Manager, Transpower and Gas  
c/o [infrastructure.regulation@comcom.govt.nz](mailto:infrastructure.regulation@comcom.govt.nz)

26 June 2024

## **Transpower Individual Price-Quality Path for the regulatory period commencing 1 April 2025 (RCP4): Draft decision**

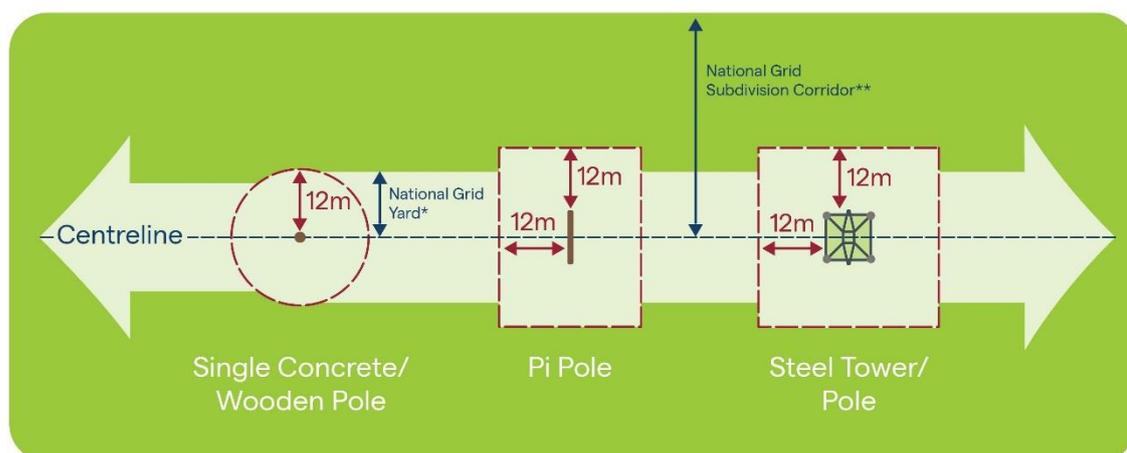
- 33 Under this approach, Transpower seek setbacks for yards and corridors to control land use around its assets – refer to the National Grid Yard/Corridor diagram below:

\* National Grid Yard: 10m for single concrete/wooden pole lines, 12m for all other line types  
 \*\* National Grid Subdivision Corridor: 14m, 32m, 37m or 39m depending on line voltage

- 34 In summary, the NPSET corridor programme is a strategic programme to seek “protective” provisions in statutory planning documents under the (RMA). The provisions we seek in Plans enable use and protection of Transpower assets. Without such protective positions, accessing and maintaining Transpower’s transmission lines will gradually but perceptively become much harder and, consequently, more expensive.
